AEP:NRC:0745M

Attachment A

Proposed Revised Technical Specifications Pages for
D.C. Cook Unit 1.

Environmental and 10 CFR 50.92 justifications for those Technical Specifications changes (enclosed in Attachment A) associated with the extension of the peak pellet burnup allowed in fuel supplied by Exxon Nuclear Company.

FIGURE 3.2-3 $K(Z)$ - Normalized $F_0(Z)$ As A Function
of Core Height For Westinghouse Fuel

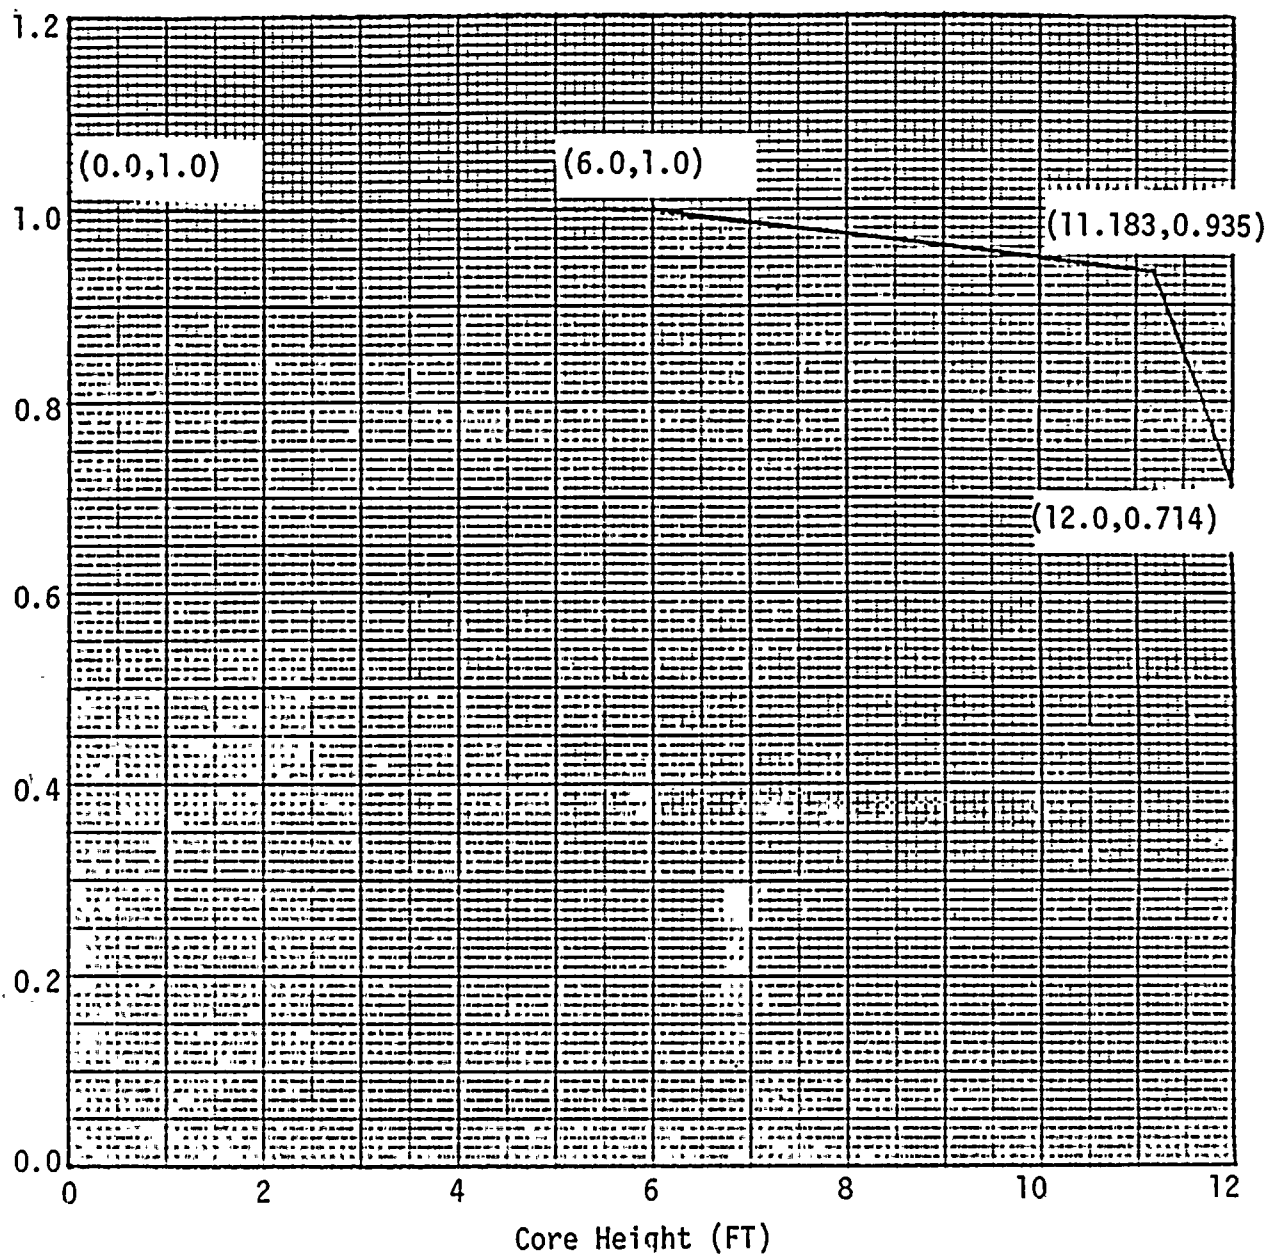
The justification for an increase in the F_Q allowed in fuel supplied by Westinghouse to 2.10 is based on a large break analysis which was performed with the December 1981 version of the Evaluation Model modified to incorporate the BART computer code. The analysis specific to Donald C. Cook Nuclear Plant, Unit 1 is included as Attachment D to this letter.

On the basis of the above evaluations, where the only differences from previously analyzed results are the change in the power level from 3250 MWt to 3411 MWt and an increased peaking factor F_0 from 1.97 to 2.10, which is based upon a change in the methods used to perform the analysis; and since the results of such analysis are within the guidelines specified in 10 CFR 50.46, we conclude that the change will not involve a significant hazards considerations as defined by 10 CFR 50.92. Also since the accidents analyzed will not result in an increase in the radiological source term, we believe this change will not have an adverse effect to the environment.

FIGURE 3.2-4

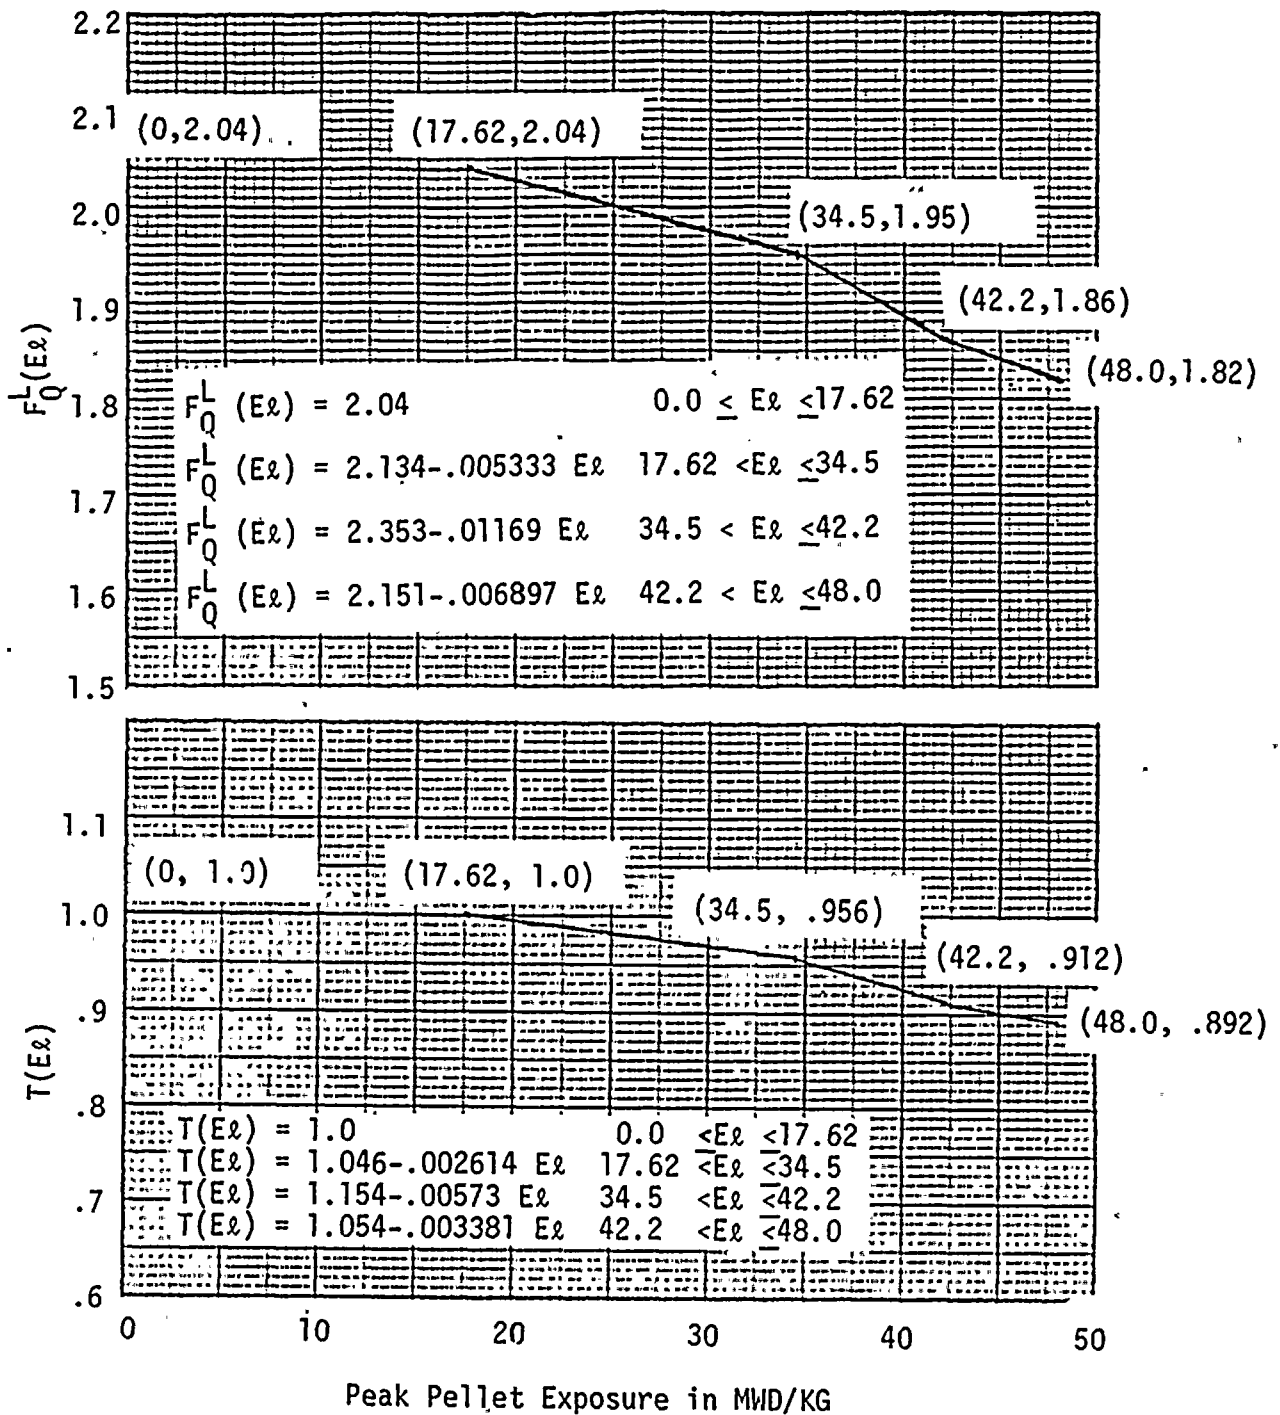
The justification for an increase in the allowed peak pellet burnup in fuel supplied by Exxon Nuclear Company (ENC) from 42,200 MWD/MTU (42.2 MWD/KG) to 48,000 MWD/MTU (48.0 MWD/KG) is based on analyses performed on the mechanical design, LOCA-ECCS analysis, and review of significant hazards and environmental considerations.

A LOCA/ECCS analysis was performed to extend the peak pellet exposure from 42,200 MWD/MTU (42.2 MWD/KG) to 48,000 MWD/MTU (48.0 MWD/KG). The results of these analyses are presented in XN-NF-83-61, August, 1983, which extends the analyses presented in XN-NF-81-07, February, 1981. The end-of-life calculated peak cladding temperature (PCT) is 1736°F, occurring 262 seconds into the accident at a location 9.25 feet from the bottom of the active core. Assuming a 42°F increase in PCT from an earlier sensitivity study for a conservative estimate of maximum LPSI flow, the PCT will be 1778°F. The analysis of the limiting break for the D.C. Cook Unit 1 reactor with the ENC WREM-IIA and selected EXEM/PWR ECCS evaluation models shows that the reactor can operate at allowed total peaking F_0 of 1.82 and F_H of 1.55 at a peak pellet burnup of 48,000 MWD/MTU (48.0 MWD/KG) and continue to meet the 10 CFR 50.46 criteria with analyses performed in conformance to 10 CFR 50 Appendix K requirements.
